Reference No. 17-0075

This letter is in response to your June 27, 2017, email requesting clarification of the Hazardous Materials Regulations (HMR; 49 CFR Parts 171-180) applicable to drop testing requirements for Intermediate Bulk Containers (IBCs). Specifically, you ask whether the scenario you provide meets the criteria in § 178.810(e) for a failure of the drop test. You provide pictures showing a broken plastic fitting on a pump mounted to the top neck fill on an IBC and explain that the opening is located at least six inches above the fluid level of the package. Additionally, you explain that the test lab noted, "minor discharge, but no continued leakage."

Subject: Request for Interpretation

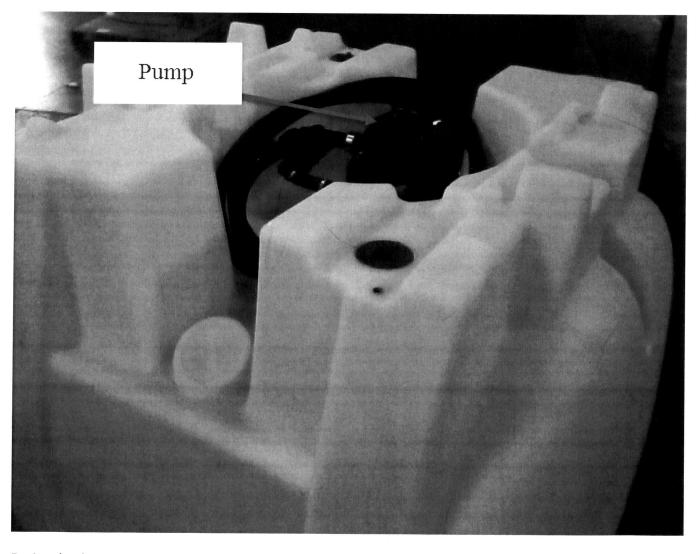
During the drop test at a third party test lab, the plastic fitting next to the pump broke as shown below.

According to the test lab, "there was a minor discharge, but no continued leakage." The concern would be whether or not this would be unsafe to be transported for salvage or disposal (per 178.810 (3) (e). I spoke with Eamonn on the DOT hotline and he was unable to address this "performance" standard.

Since the open fitting is over 6 inches above the fluid level, would this be considered unsafe for transport?

The criteria for passing the drop test in § 178.810(e) state, "there may be no damage which renders the IBC unsafe to be transported for salvage or for disposable." Based on the scenario you provided, it is the opinion of this Office that a damaged fitting that creates an opening in the package renders the IBC unsafe to be transported.

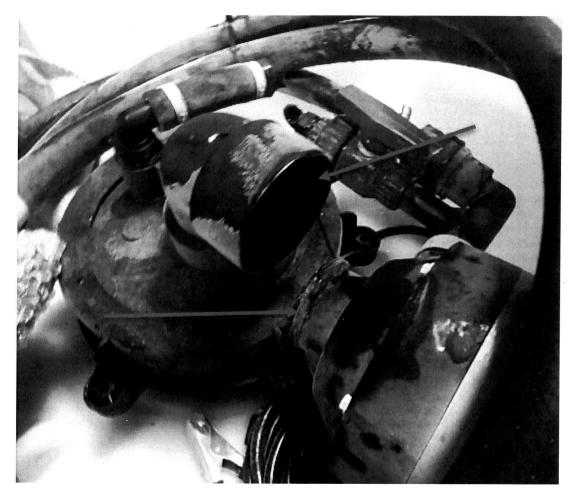
We have a 220 gallon IBC tank with a 12VDC pump mounted on the top fill neck as shown below.
